McCULLOCH SERVICE BULLETIN

NO. 1686

MODEL MAC 10-10, PRO 10-10, PRO MAC 10-10, PRO MAC 55 and PRO MAC 555

SUBJECT Muffler Kit, P/N 95318, and Screen Cover Kit, P/N 95320

FIG. 1

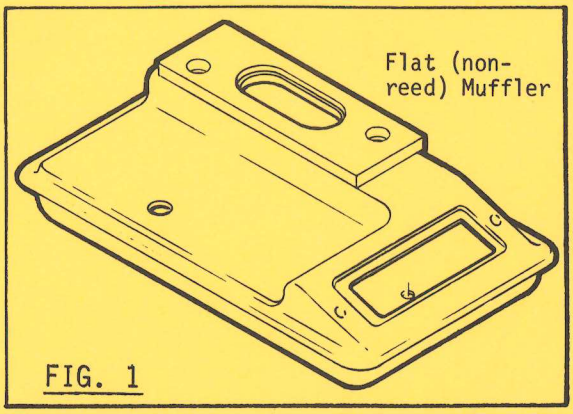
We have re-instated the two-louver muffler cover previously used with flat, non-reed type mufflers (Figure 1). This cover, along with Cover Screen, P/N 89432B, will be included in Muffler Kit, P/N 95318 (previously P/N 89428B), and Screen Cover Kit, P/N 95320.

FIG. 2

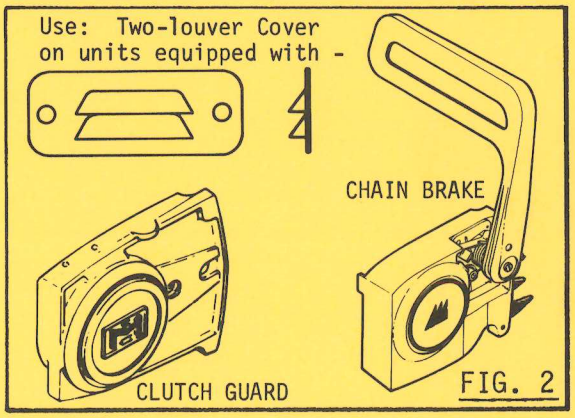
The two covers are included in each kit for backfitting purposes. The two-louver cover **must** be used on units equipped with clutch guards or CHAIN BRAKE assemblies that do **not** extend over the muffler (Figure 2) to direct the exhaust flow away from operator.

FIG. 3

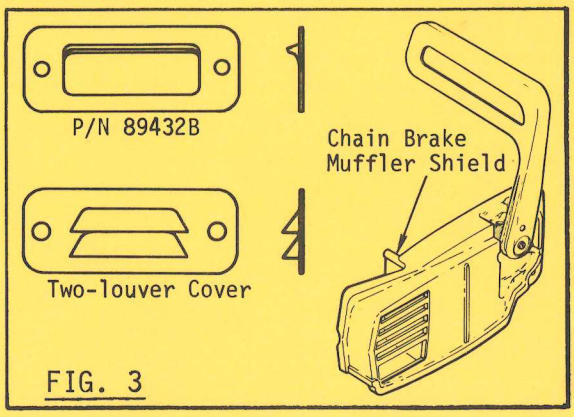
On units currently equipped with CHAIN BRAKE/ Muffler Shield assemblies that extend over the muffler (Figure 3), either of the muffler covers may be used **except** in the states of Oregon, Washington and California. In these states, units originally equipped with P/N 89432B cover screen **must** use the same type cover screen as service replacement to meet forestry requirements concerning exhaust, gas and skin (muffler and adjacent part surfaces) temperatures. These regulations are strictly enforced in the previously mentioned states.

Units in Oregon, Washington and California that were originally equipped with the two-louver cover may use that type cover as replacement. In other areas, use of either cover is probably optional. However, be certain to check and follow local regulations at all times.
